**MEMORANDUM**

DATE: July 2, 2013

SUBJECT: **BZA Case 18579** – request for special exception to establish a private school and child development center in and variance relief for a proposed three-story addition to the Holy Trinity School generally located at 3514 O Street NW

Figure 2

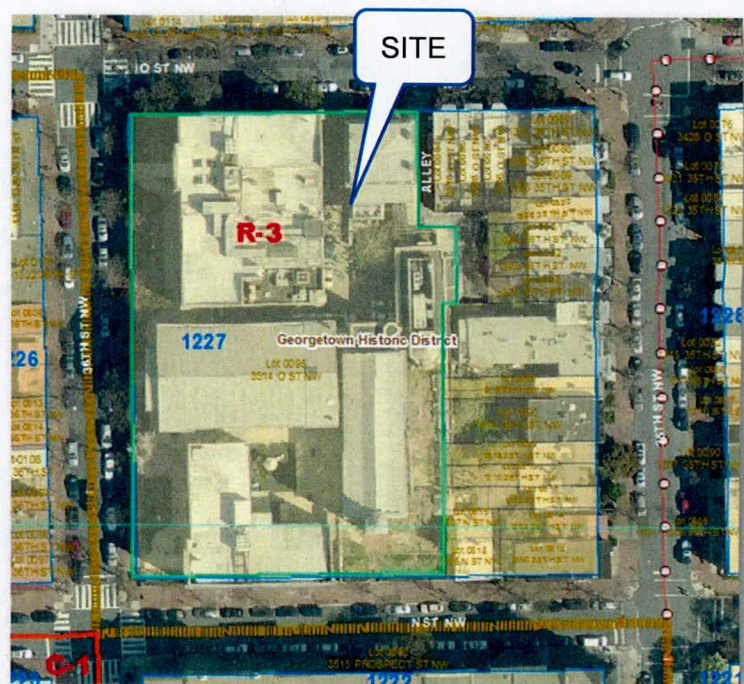
The screens enclosing the additional roof structures vary for the existing enclosures which appear taller in the submitted building elevation.

The submitted plans do not include elevations of the actual enclosures or an explanation of the materials that would be use.

The applicant explained that the existing mechanical penthouses are visible from the street, while the proposed penthouses would be positioned on the roof so not be visible from the street. If fact, the visibility of the new rooftop equipment factored in the Old Georgetown Board granting its approval of the proposed additions (refer to the Agency Comments section below).
